April 16, 2018

SUBJECT: Approval of Change Order #6 for Vapor Mitigation System  
Dutch Cleaners, 403 S. Main Street, Cedar Grove, Wisconsin  
WDNR BRRTS # 02-60-271527

### PROPOSED VAPOR MITIGATION SYSTEM LAYOUT

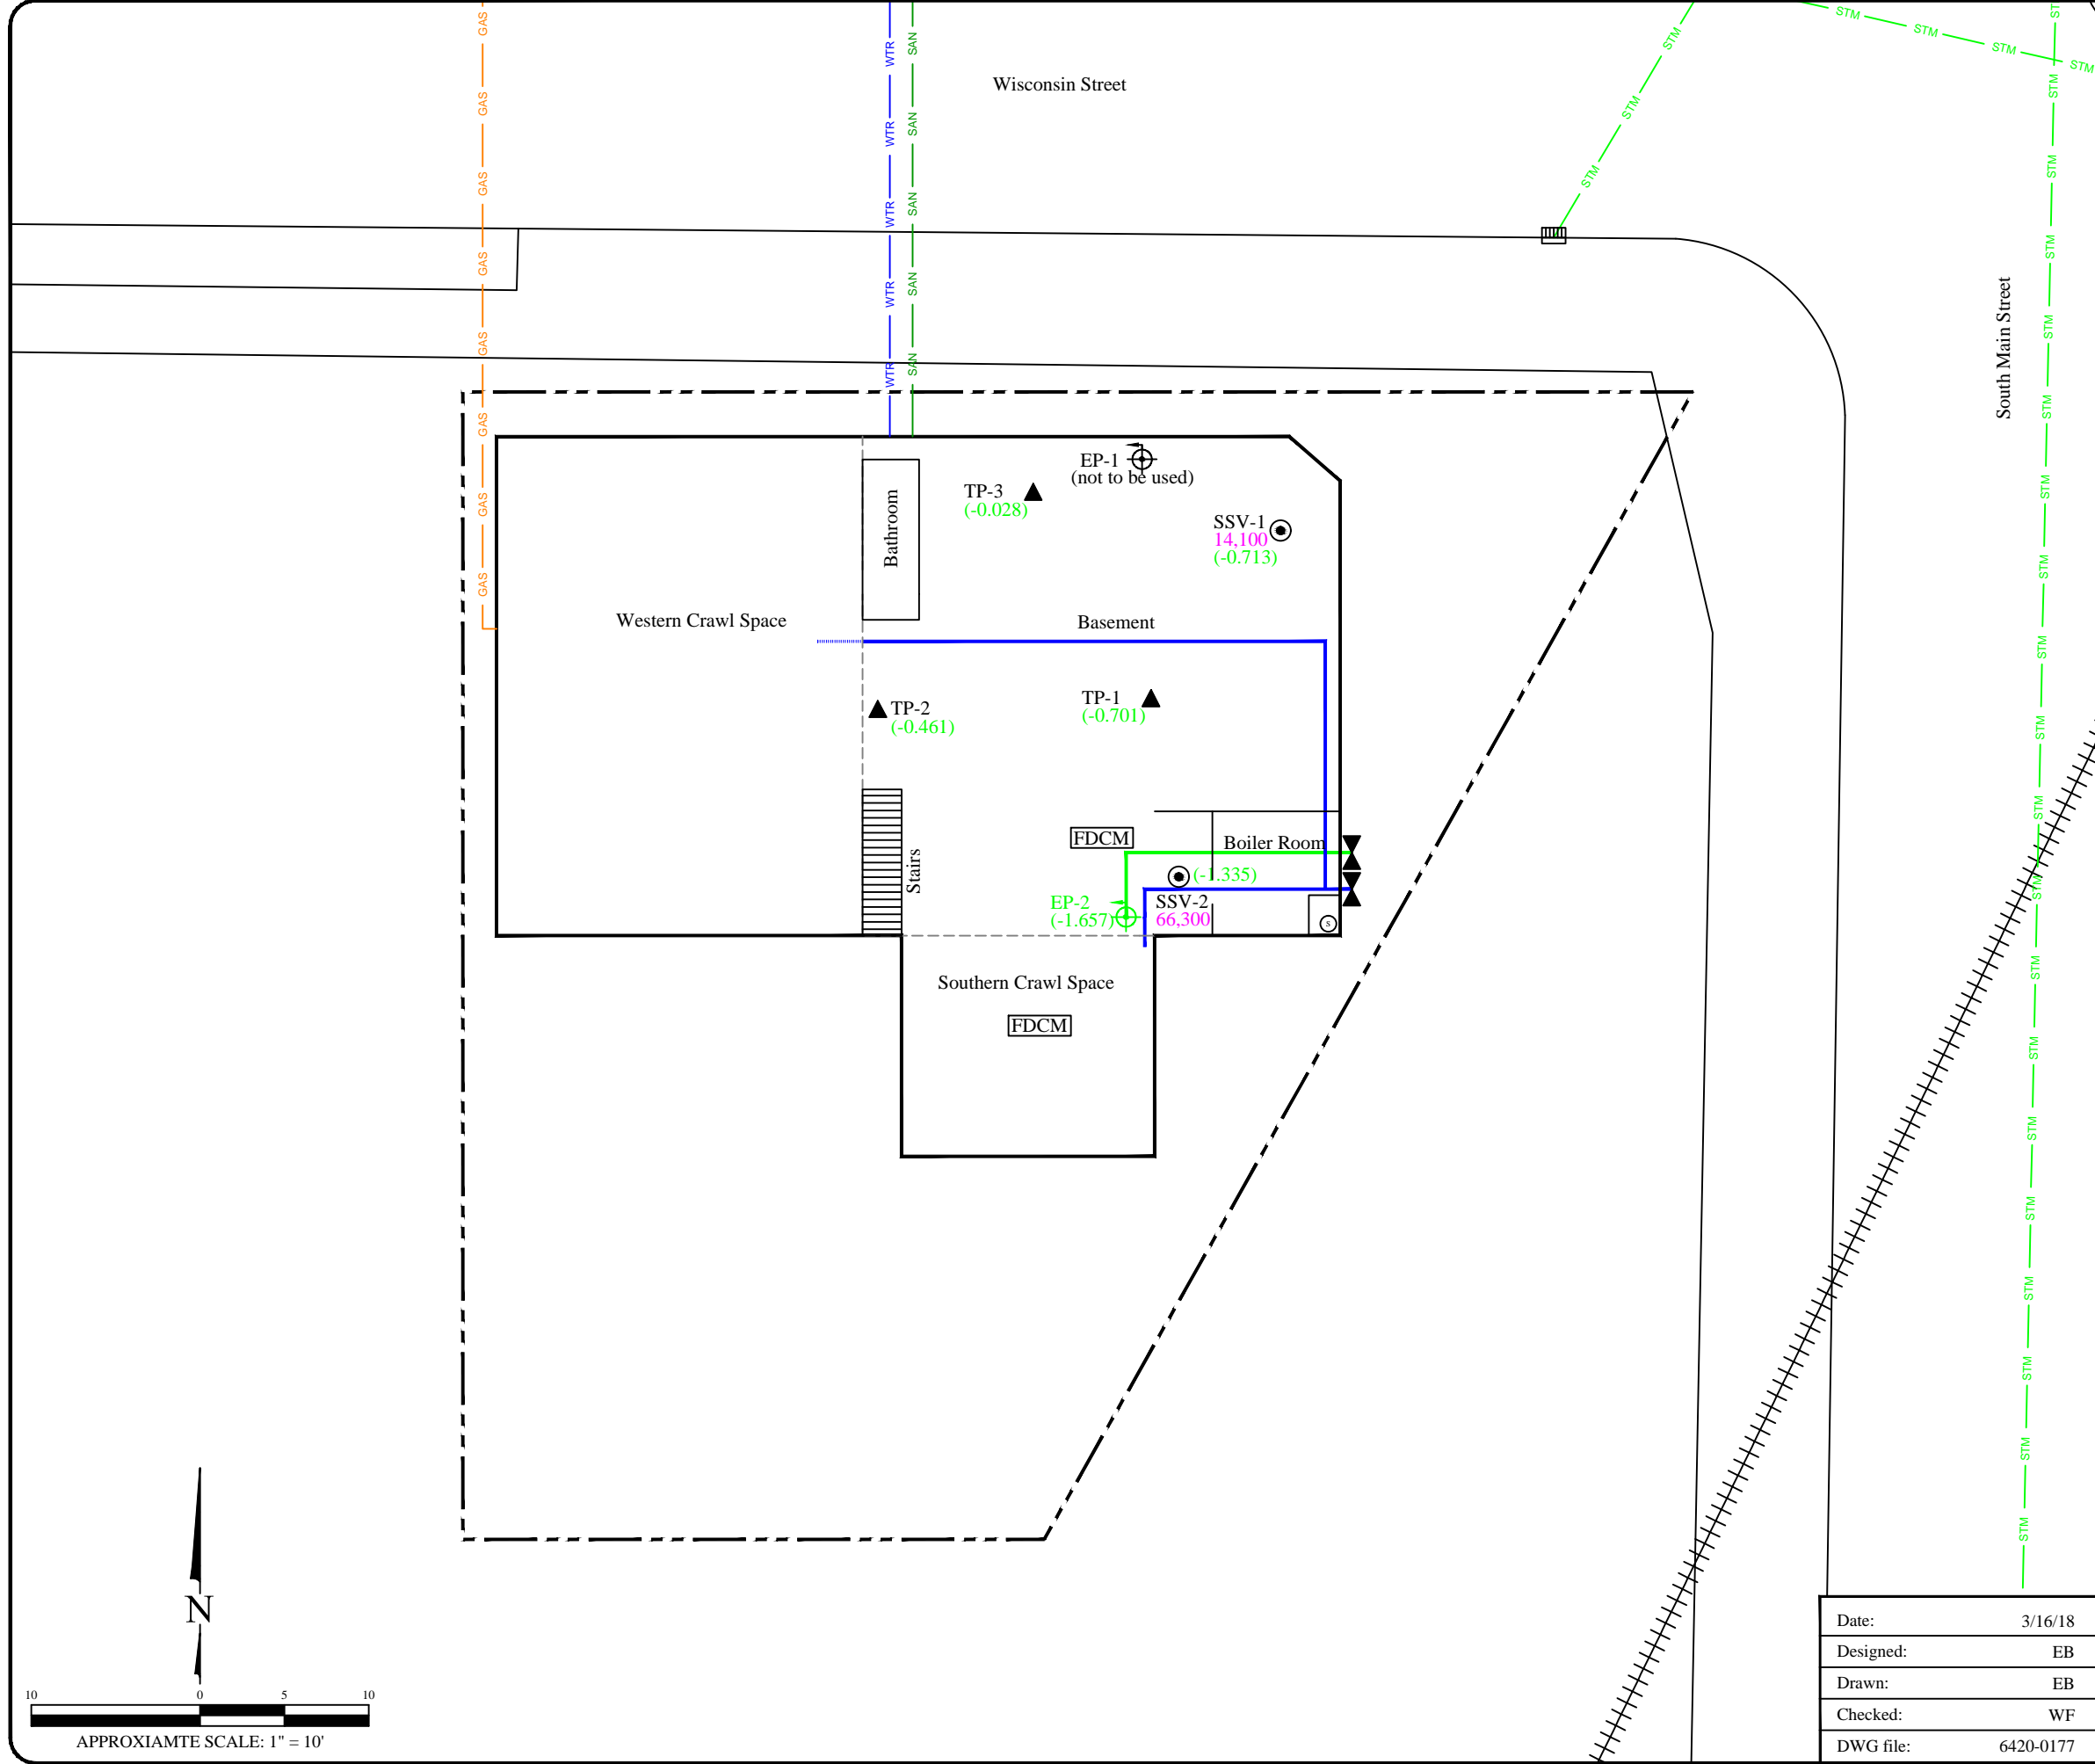
- Installation of a SSDS consisting of one sub-slab extraction point connected with conveyance piping to a RadonAway RP 265 fan (or similar) and vented a minimum of 2 feet above the building roofline. The proposed SSDS layout is shown on Figure 1.

- Installation of a SMDS to mitigate potential vapors within the western and southern crawl spaces. The proposed SMDS layout is shown on Figure 1.
  - The western crawl space soils will be sealed off with plastic sheeting and polyurethane caulk. Perforated piping will be installed beneath the plastic sheeting and used as a depressurization point. That piping will be connected to conveyance piping and routed to a RadonAway RP 380 fan (or similar) mounted near the blower for the SSDS and exhausted above the roofline.

- The entire cavity of the southern crawl space will be vented by using plastic sheeting to cover the entrance. The plastic sheeting will be bonded to create a seal using

polyurethane caulk. Conveyance piping will be used and connected to the same blower as the western crawl space.

The Department approves of the change order requested as outlined in the March 2018 Report.
